BAR CASE # 2013-00066 &  
2013-00067

City Council  
February 22, 2014

**ISSUE:** Appeal of a decision of the Board of Architectural Review, Old & Historic Alexandria District, approving a Permit to Demolish/Capsulate and Certificate of Appropriateness for new addition and alterations

**LOCATION:** 207 Prince Street

**Figure 7:** Existing first floor

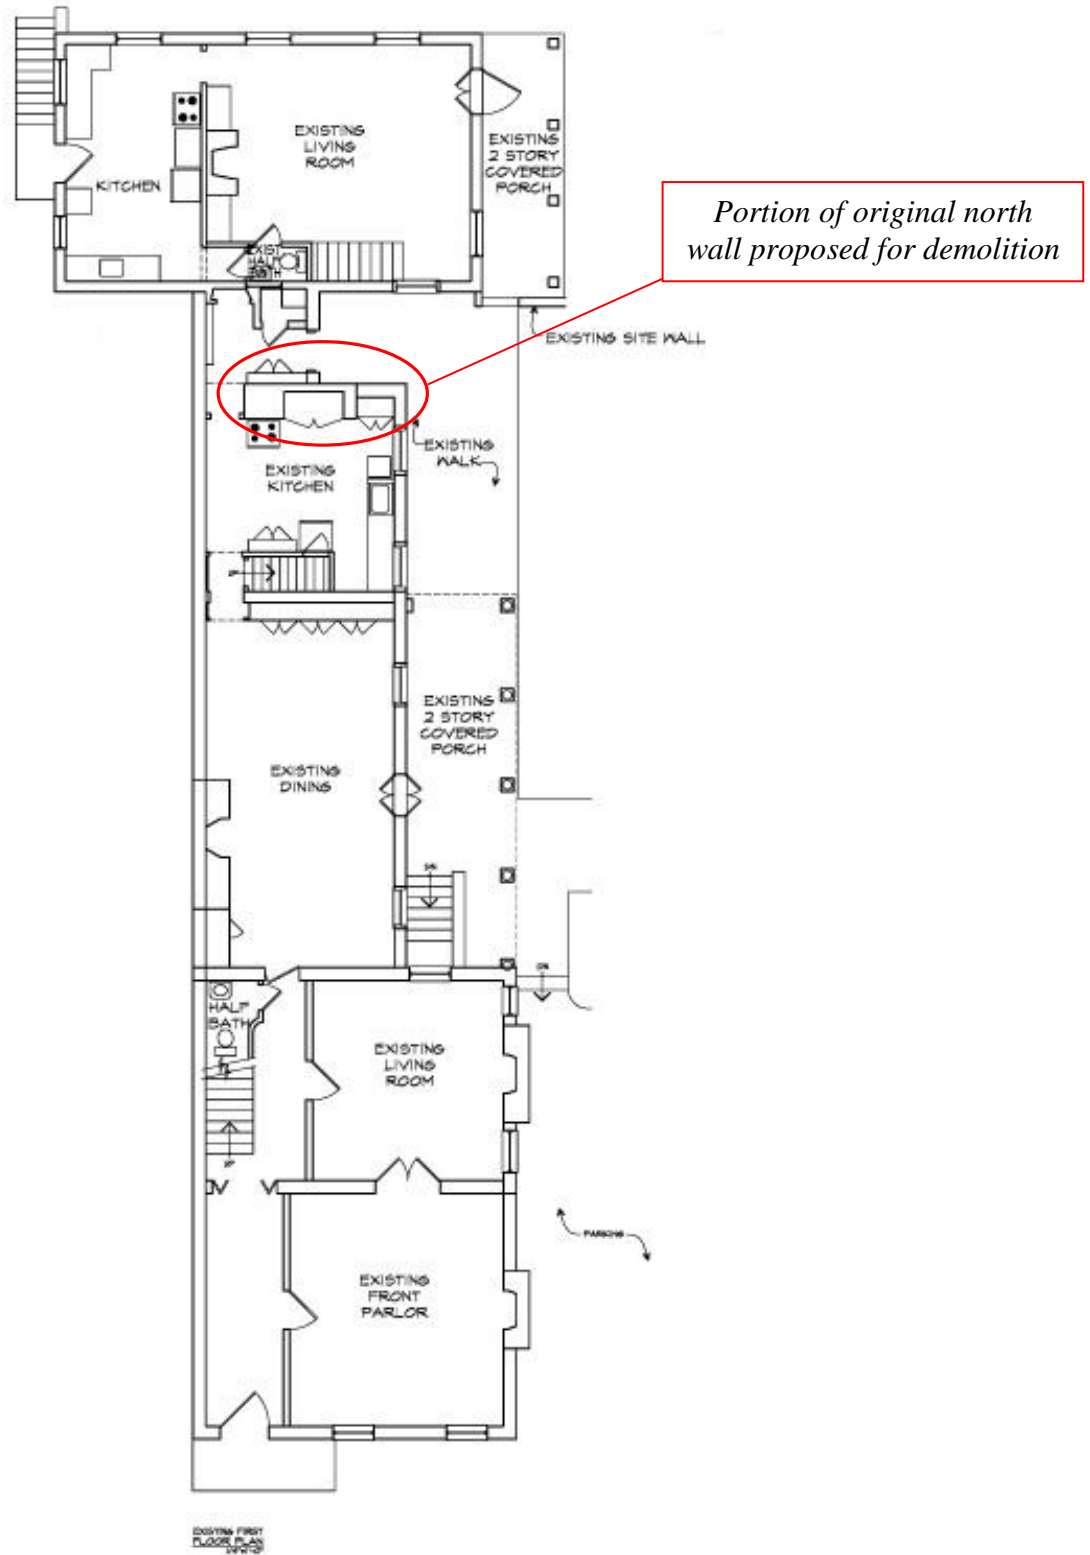
**Figure 5:** Portion of the east elevation at the first floor that is proposed for demolition and capsulation for the kitchen addition

**Figure 9:** Initial proposal showing first floor plan, as submitted by applicant. Both the north and east masonry walls of the existing kitchen are removed entirely at the first floor.

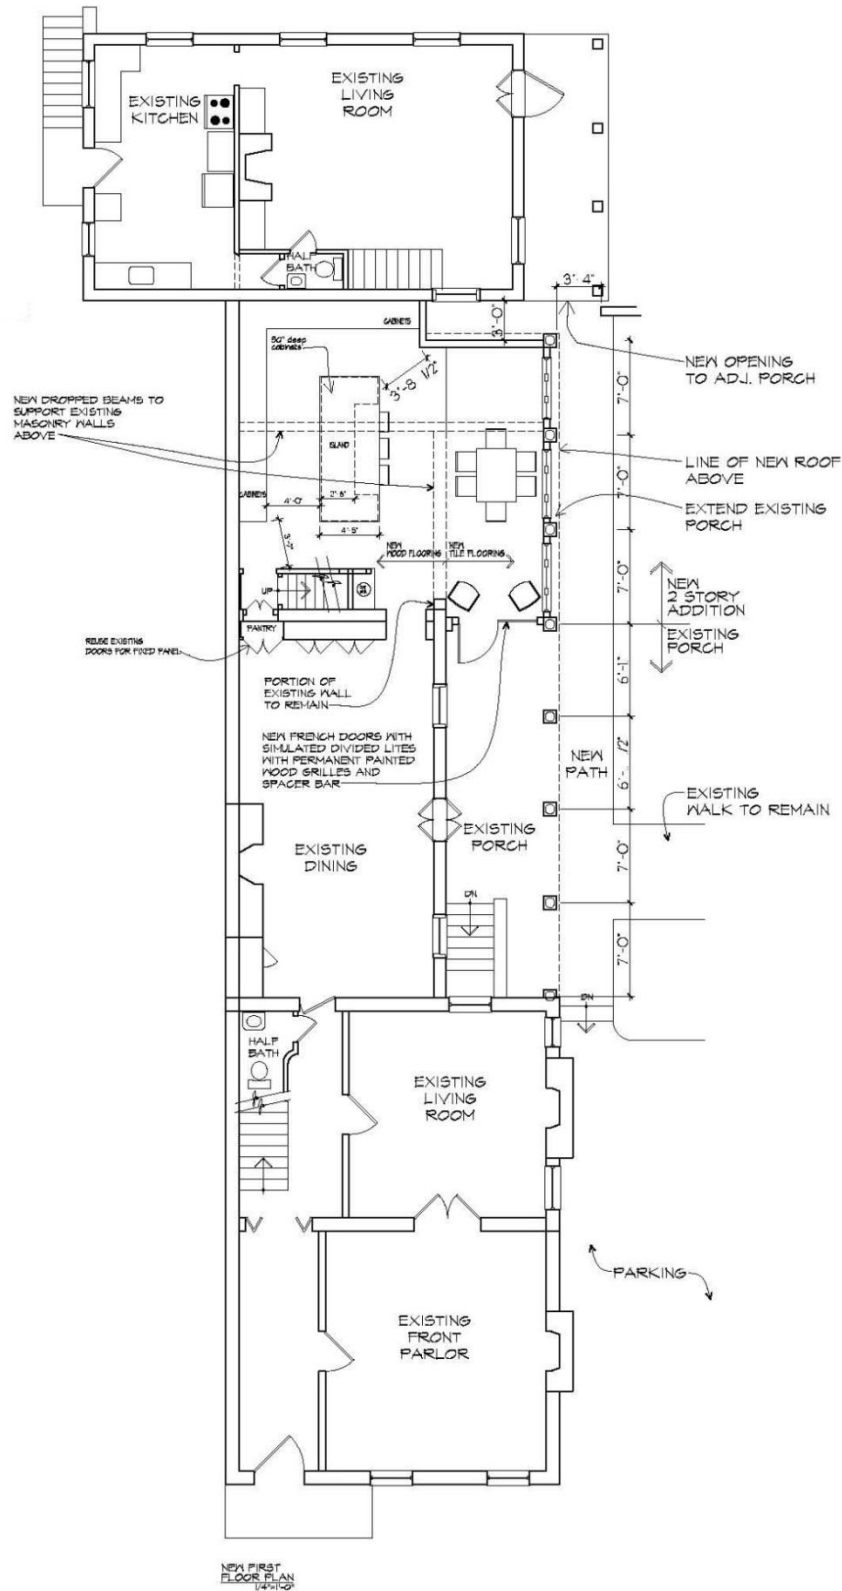
Staff expressed concern with the initial design, as the proposed addition significantly diminished legibility of the northern portion of the ell, where the existing kitchen is located, as a discreet building feature. The proposed second-story porch matched exactly the existing porch, now historic in its own right, and then obscured the building masses that comprise the historic ell. This made it difficult to understand the growth and development of the original dwelling and is contrary to the Secretary of the Interior's Standards for Rehabilitation, particularly #9 and #10 which state that:

Therefore, Staff recommended to the applicant an addition much smaller in height and floor area that does not try to match the original building or the 1930's Colonial Revival alterations, but stands on its own. A delicate single story kitchen projecting slightly beyond the existing porch, much like a Colonial Revival conservatory, would read as a garden feature rather than part of the house and take up very little useable open space in the garden. Like the plan submitted by the applicant, a one-story addition would still provide generous kitchen work space, substantial pantry storage and circulation for entertaining and daily use by the family. The masonry opening to the garden room could be a large segmental masonry arch with a wood vaulted ceiling in the garden room/breakfast area to allow light back into the kitchen. A similar design was recently approved by the BAR at 504 Prince Street. The alternative designs suggested by Staff are illustrated in *figure 10* and *figure 11*.

Figure 13: Revised proposal by applicant and current application submission

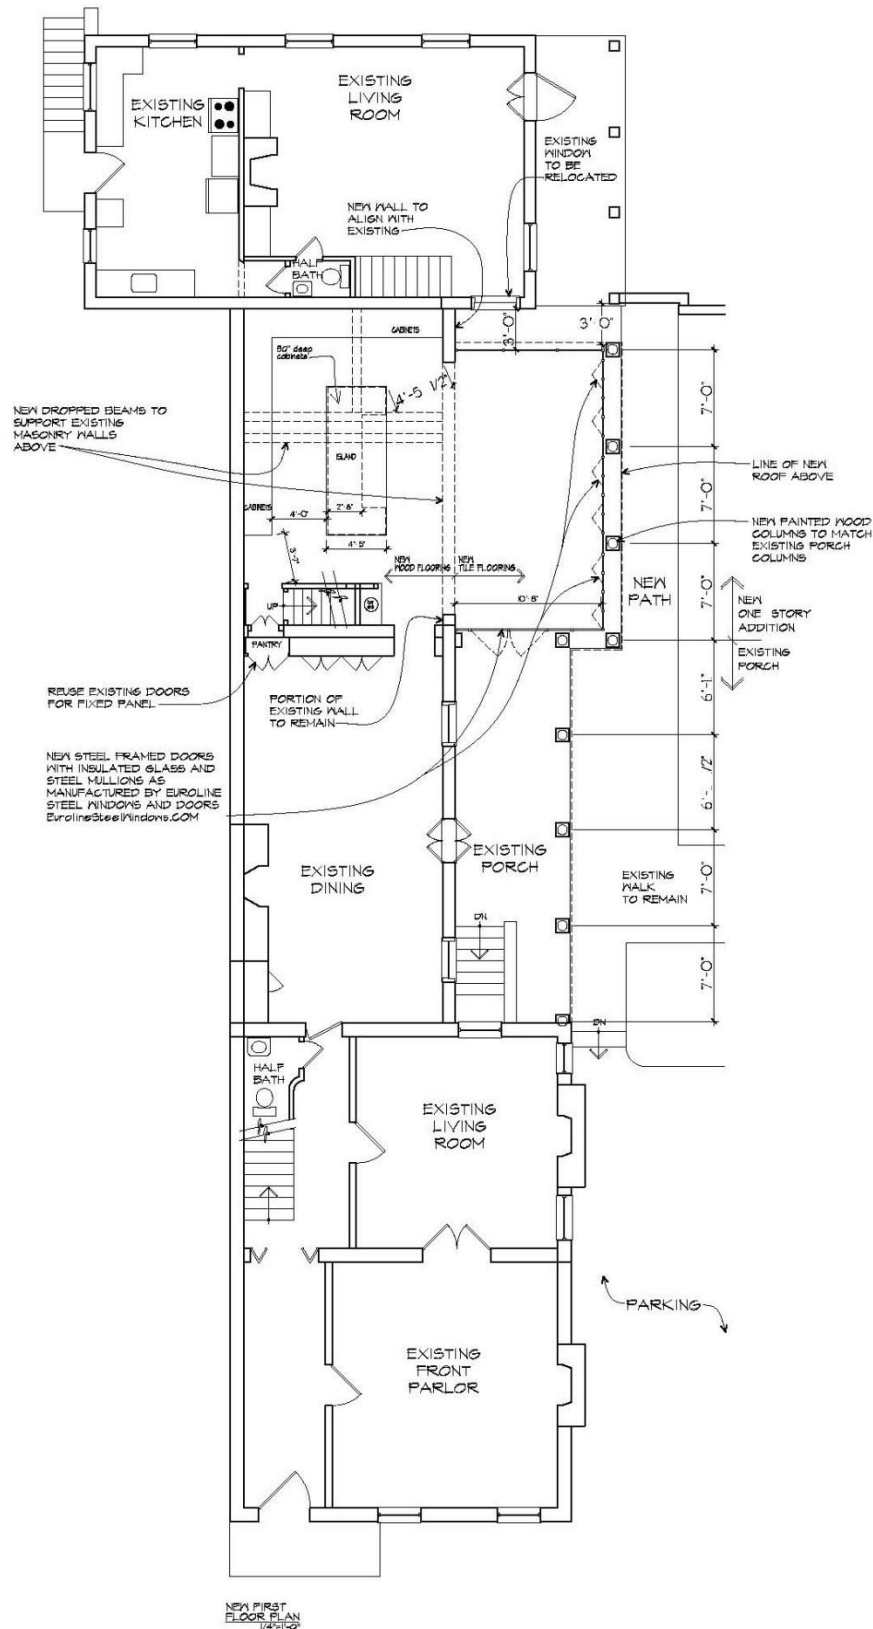
Although Staff would prefer that a greater portion of the north and east masonry walls at the first floor be preserved and incorporated into the new plan, Staff acknowledges that these masonry walls have been altered many times in the past and has no objection to the exterior design of the proposed kitchen addition. As historic maps and photographs show, there have been several alterations to the east elevation over the years. The visual mass of the proposed addition has been significantly scaled back since the initial application and its impact on the existing east elevation minimized by the elimination of the second story covered porch.

The proposed enclosed porch design parti is often used on historic buildings to avoid competing with the primary building mass. The size and spacing of the new columns recall the existing porch without replicating the segmental arch detail of that Colonial Revival era design. The modern steel and glass doors on the proposed addition float behind the columns and clearly distinguish this infill as a modern addition. The applicant has alluded to floor material changes and ceiling design that will visually interpret the location of the original masonry walls and it is Staff's recommendation that this be made a condition of the Certificate of Appropriateness. Furthermore, Staff recommends that an approval for a Permit to Demolish include the condition that the historic floor joists of the first and second story remain in place. These alterations, if approved, will preserve the historic integrity and understanding of the evolution of this important house while allowing its inhabitants a contemporary kitchen and living space.
